CBER CMC BLA Review Memorandum

BLA STN 125714

**lisocabtagene maraleucel
BREYANZI**

Figure 16 JCAR017 formulation and dose preparation process

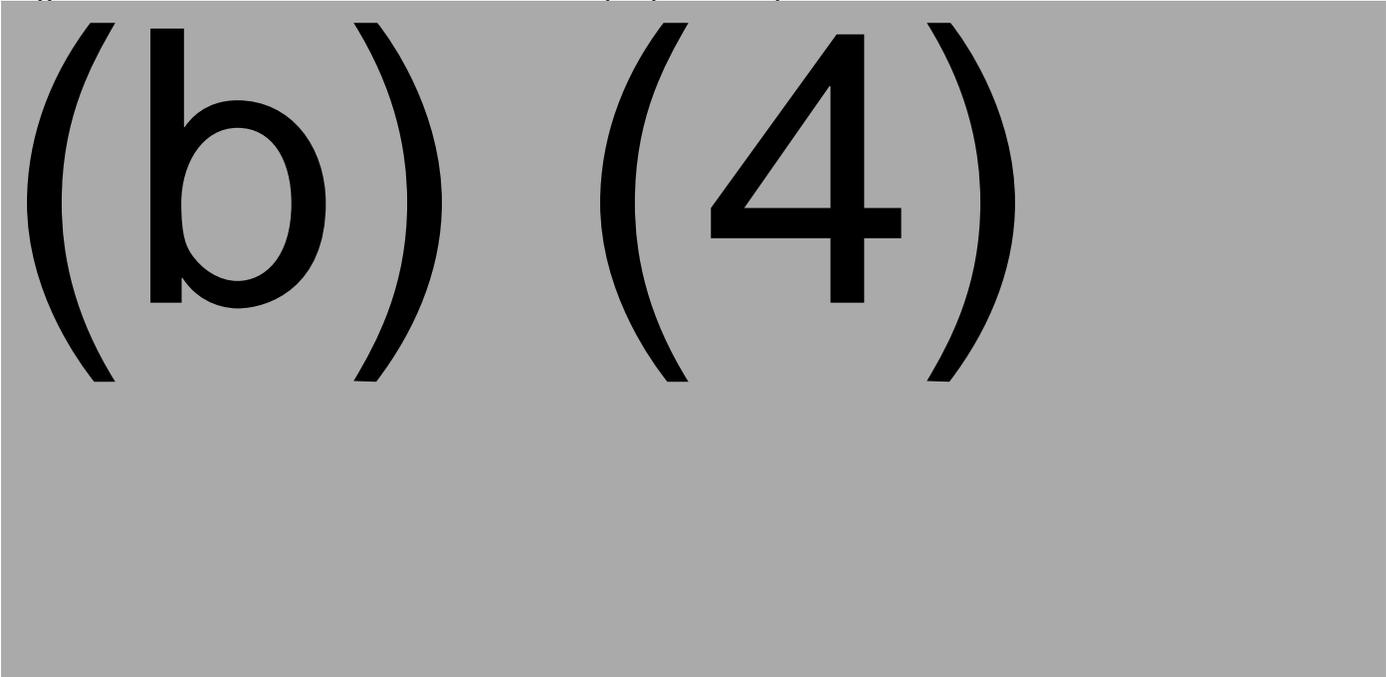
Reviewer comment: These calculations are based on proposed dose at the time of review: 100×10^6 CAR+ T cells (50×10^6 CAR+ cells per DP).

Reviewer comment: This proposal considerably reduces the overfill and stays within the manufacturing experience during the clinical study. Importantly, the reduction in final cell concentration should not be substantial enough to affect DP release testing, I would be concerned about the impact on release testing if the concentration was changed by more than (b) (4).

Reviewer comment: Juno's risk assessment to support the revised formulation strategy was based on the proposed target dose of 100×10^6 CAR+ cells. The clinical review team recommended an increased final dose range with an upper dose of 110×10^6 CAR+ cells, as compared to Juno's proposed 100×10^6 CAR+ cells, and consequently (b) (4) CAR+ cells per component as indicated in Table 65. The formulation review has focused on administration of the top of the dose range as the highest allowable dose is usually targeted for infusion, and is recommended in the PI. Although overfill is reduced, more than the intended dose may be shipped to the clinical site and therefore the concern for medical errors and over dosing remains.
